**MAYOR & COUNCIL COMMUNICATION**

**AGENDA ITEM:** Savona 3<sup>rd</sup> Addition Residential Subdivision – Final Plat

PLANNING COMMISSION  
DATE: 8/24/15  
AGENDA ITEM: 5B – BUSINESS ITEM  
CASE # 2015-28

ITEM: Savona 3<sup>rd</sup> Addition Residential Subdivision – Final Plat  
SUBMITTED BY: Kyle Klatt, Planning Director *KK*  
REVIEWED BY: Jack Griffin, City Engineer

Date: 04/27/15 Sheet: 9 OF 21  
**Storm Sewer and Street Construction Plan**

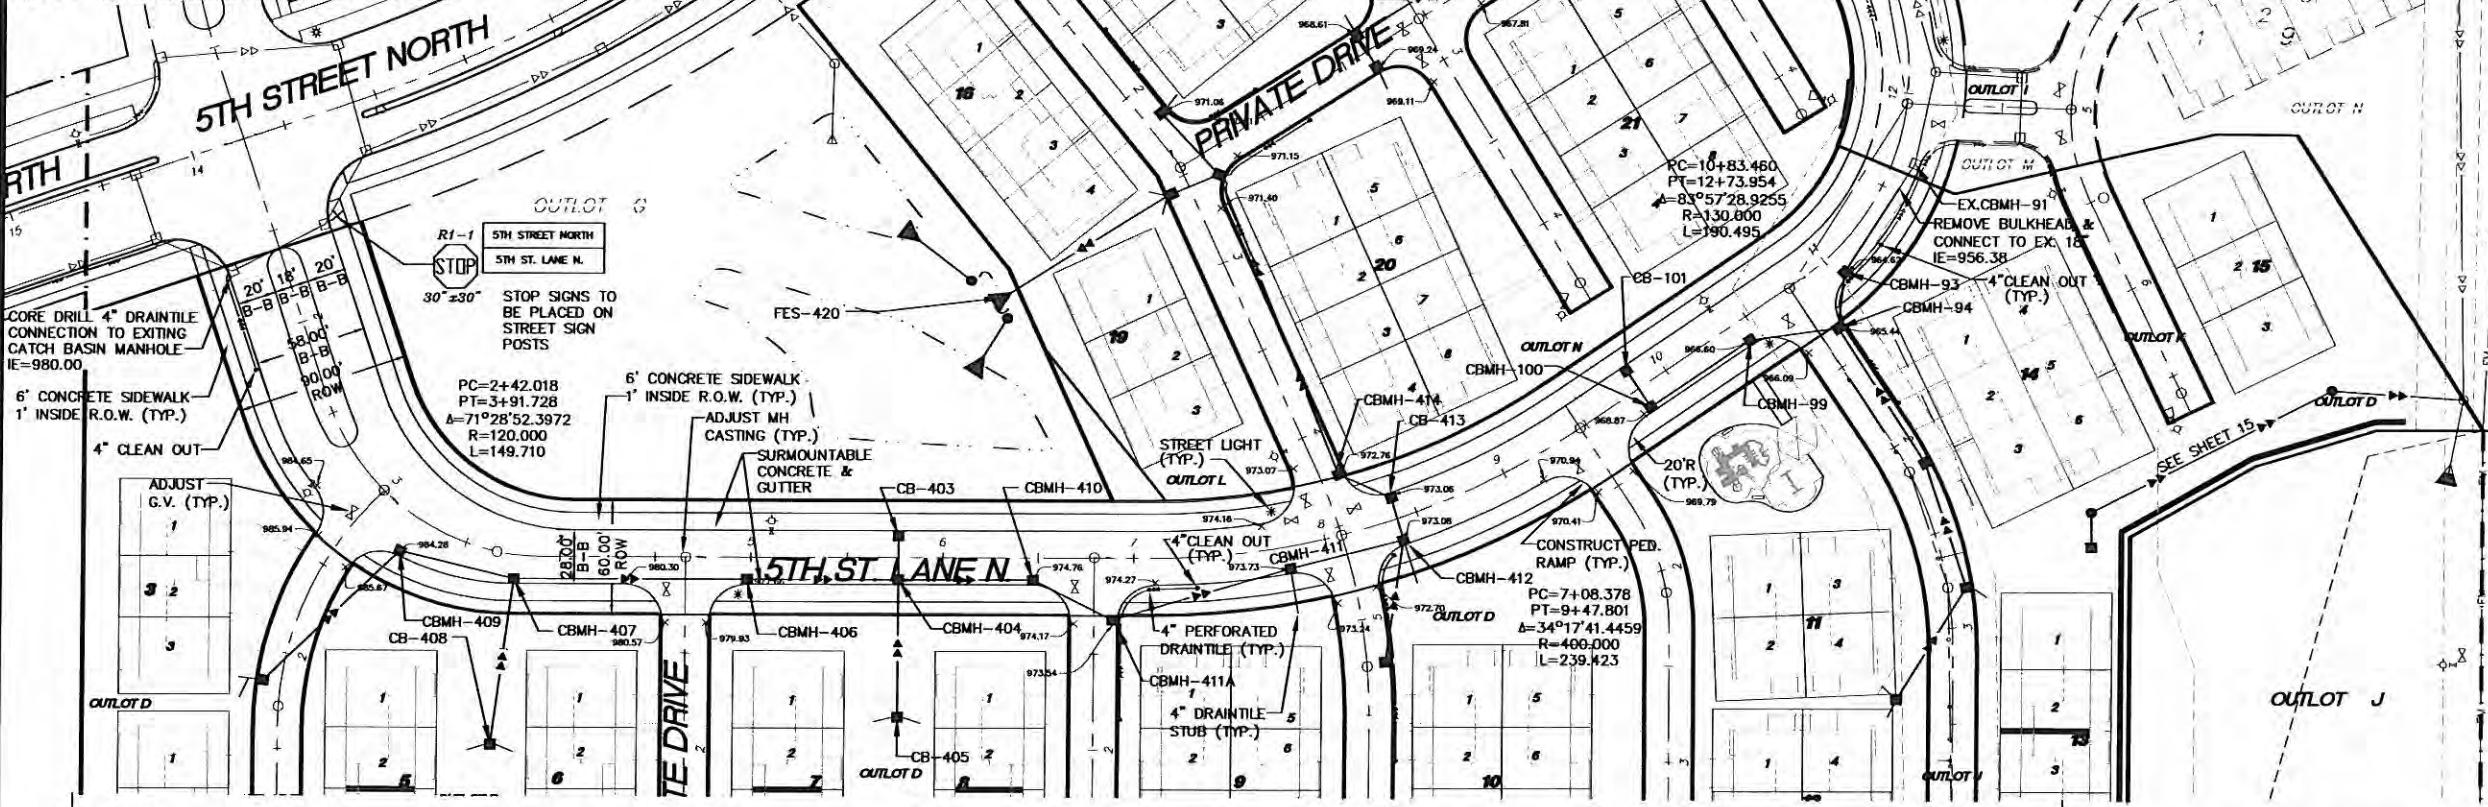
- Sheet 9 – CB-247 must be revised to allow the draitile invert to be above the top of effluent pipe.
- Sheet No. 9 – Remove "CB-250" text on Lot 3, Block 2.
- Sheet No. 10 – CB-405, CB-408, CBMH-94, CBMH-411A, CBMH-411 and CBMH-412 must be revised to allow the draitile invert to be above the top of effluent pipe.
- Sheet No. 10 – Add draitile at the low point on the southeast corner of the 5<sup>th</sup> Street Lane and 5<sup>th</sup> Street intersection.
- Sheet No. 15 – Storm sewer along Profile D must be a minimum of 15 feet from the backside of the proposed retaining wall and must be a minimum 15 inches in diameter.
- An updated Rational Storm Sewer Design Tabulation must be provided to include all storm sewer structures in Savona 3<sup>rd</sup> Addition.

Storm Sewer and Street Construction Plan  
 Date: 04/27/15 Sheet: 10 OF 21

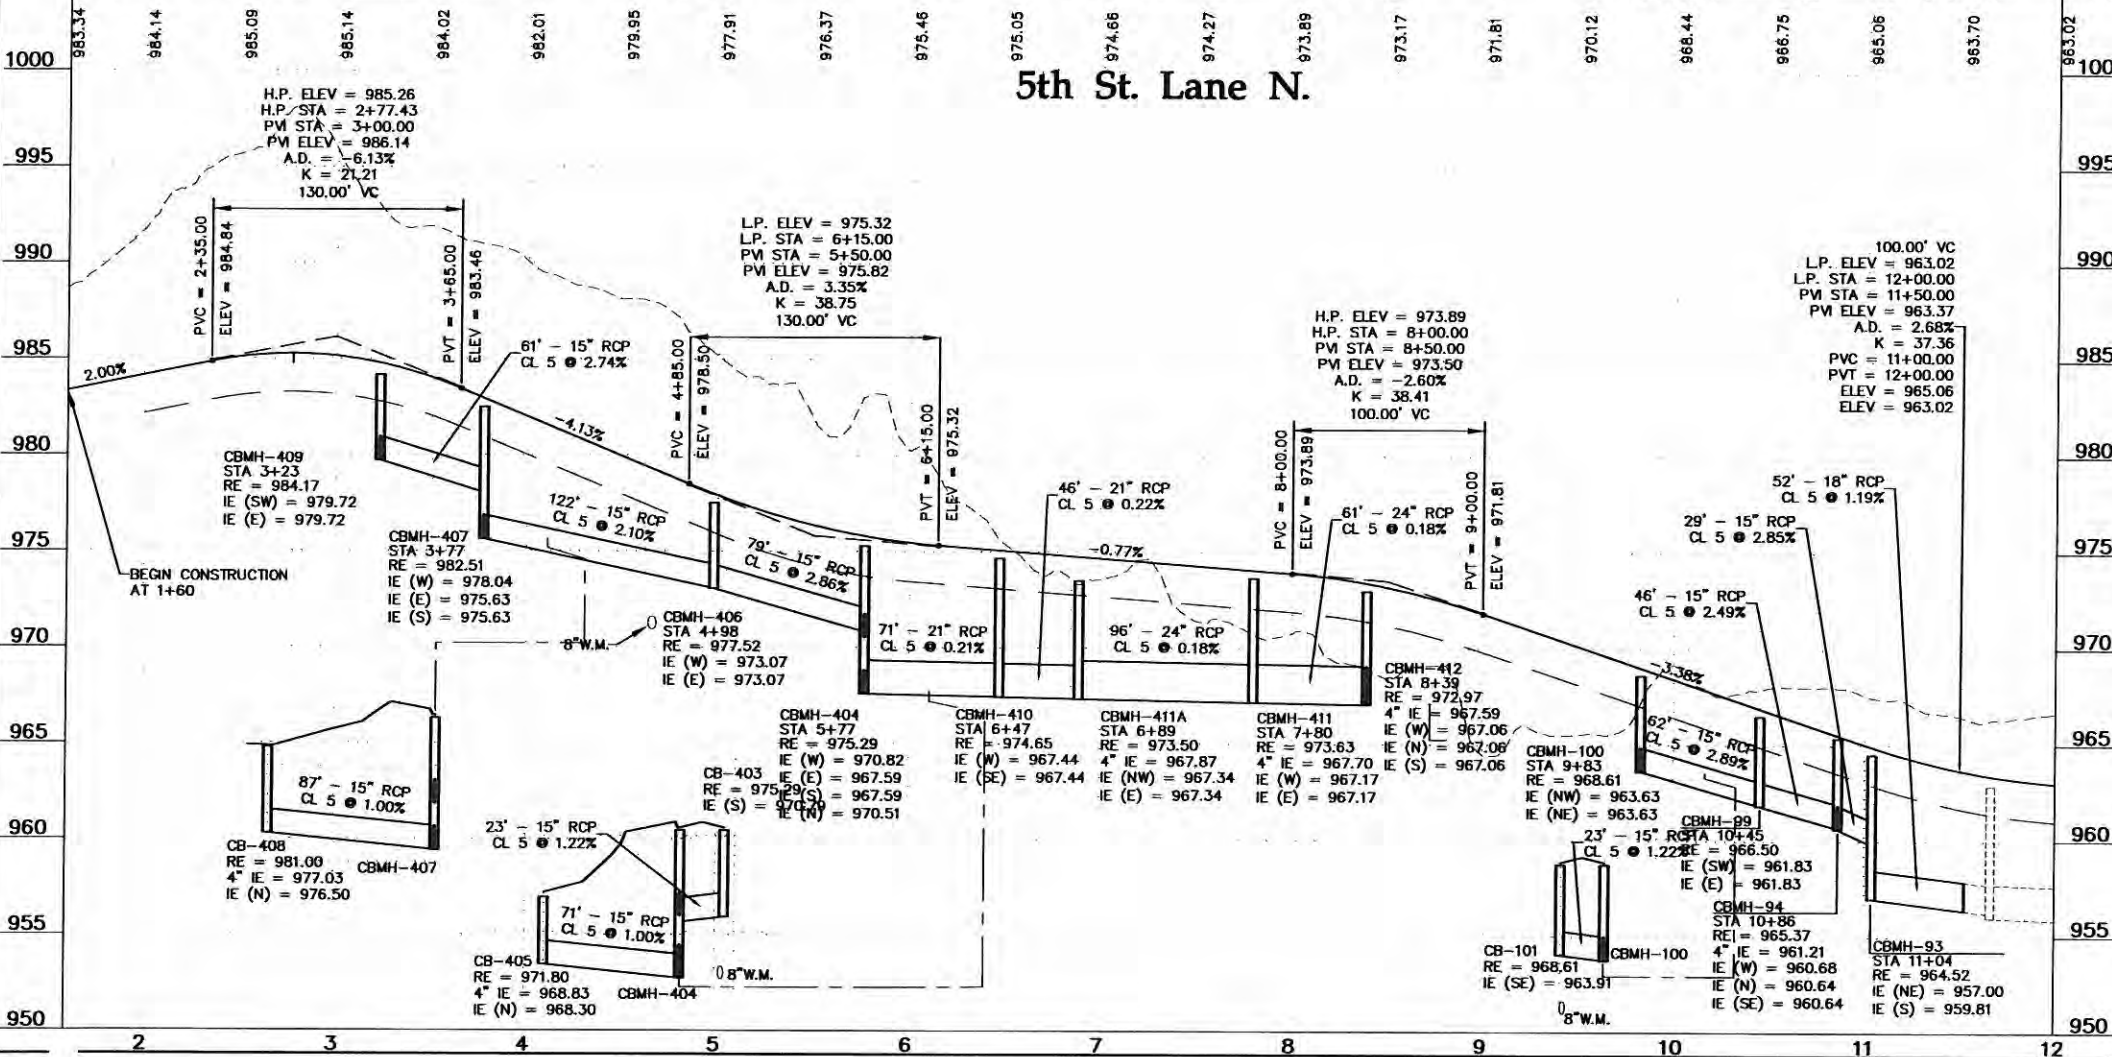
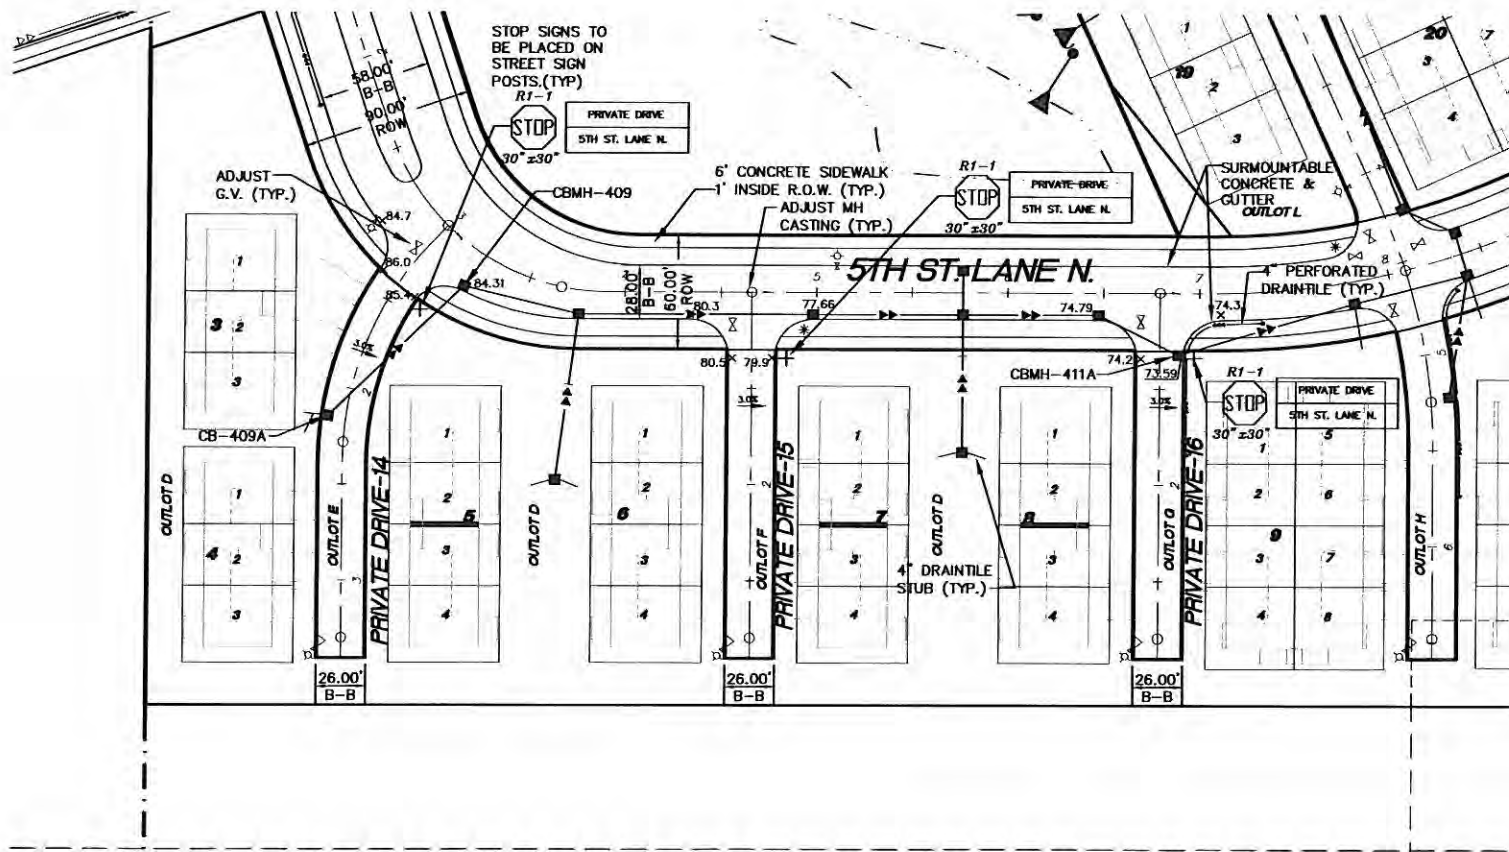
- Sheet No. 10 – Revise the Typical Section for 5<sup>th</sup> Street Lane (with Landscaped Median) to have an asphalt grade B and Traffic Level 2 (consistent with the remaining 5<sup>th</sup> Street Lane bituminous mix design).
- Sheet No. 11 – Private Drive 14 and 15 cannot have a breakover (rollover) angle in excess of 5%. This means the maximum difference between the slope of 5<sup>th</sup> Street Lane and the slope of the private drive cannot exceed 5%.
- Sheet 19 – Type III Barricades should remain on 5<sup>th</sup> Street at Junco Road.
- Sheet 19 – A paved turnaround must be accommodated at STA 29+70 on 5<sup>th</sup> Street.
- Sheet 20 – Signage for the left turn land must be added to the plan.
